## **Construct New Specialty Care Building #42**

**VA246-17-B-0374**

### **Preliminary Questions and Answers**

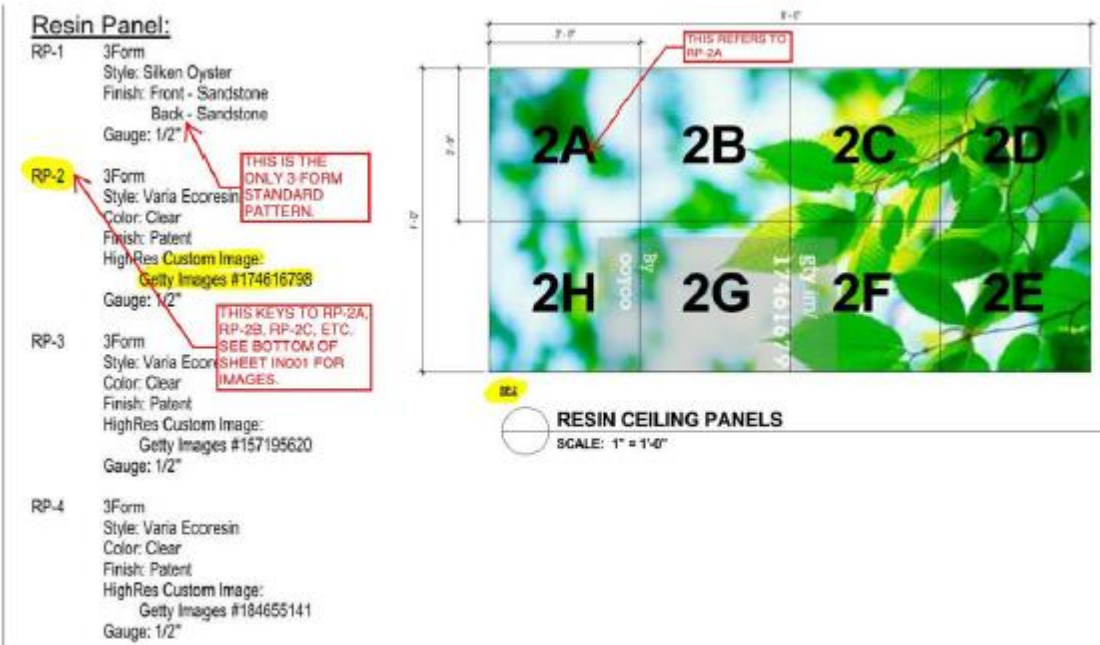
**Q7:** On drawing IN001 there are four 3-form panels sections 4'x8'. Are these units RP-1 through RP-4 different than the 2'x2' 3-form ceiling panels located on drawing AI107? I don't see anywhere on ceiling plans where there are 4'x8' panel sections.

**A7:** There is RP-1, RP-2, RP-3 and RP-4 specified. RP-1 is a standard color from 3-Form. RP-2 thru RP-4 is custom with images that must be purchased thru Getty images. (image quality must be appropriate for 4' x 8' size) The 3-Form panels come in sizes 4' x 8' in which an image will be printed on the entire panel. This 4' x 8' panel will then be broken into 2' x 2' panels that will be inserted into the 2' x 2' ceiling grid. For example, RP-2 overall has 8 pieces. These are keyed as RP-2A, RP-2B, RP-2C, etc. on the bottom of sheet IN001. The key is to locate where these panels are to be installed within the ceiling as shown on sheet AI107. Please note, refer to AI107 for the total quantity of panels. Some repeat, for example, RP-2A is used more than once.

See following for graphic explanation.
